Planning App Ref:	PL/2026/00135
Service Ref:	Drainage
Date:	09/02/2026

Demolition of existing structures and construction of 90 homes, with areas of open space, a play area, sustainable drainage infrastructure, internal roads, paths and parking areas, landscaping and associated works, plant and infrastructure and discharge of conditions 7 (boundary with Abberd Farm), 8 (Surface Water), 9 (Surface Water), 14 (Construction Ecological Management Plan), 15 (Landscape Ecological Management Plan), 16 (Lighting), 17 (Wildlife Features) and 18 (Noise Assessment) of outline planning permission PL/2022/07893

Land off Spitfire Road, Calne. SN11 8TE

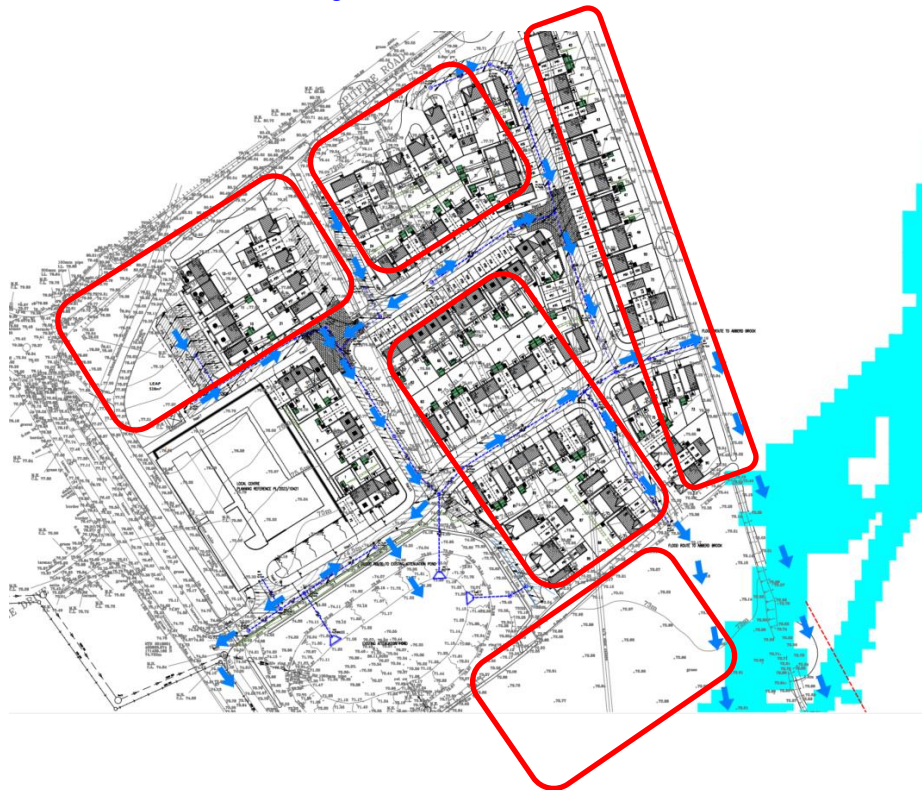
- It is noted the applicant has provided the Flood Exceedance Routing drawing, however the applicant has not provided sufficient detail to remove this condition.

The applicant must provide flood exceedance flow arrows across the extent of the development, including rear gardens, and not just along highways. The red outlines below represent where further exceedance routing arrows are required.

This information is required to demonstrate flood risk is safely managed to people & property, in line with the National Standards for SuDS: [Standard 3: management of extreme rainfall and flooding](#).
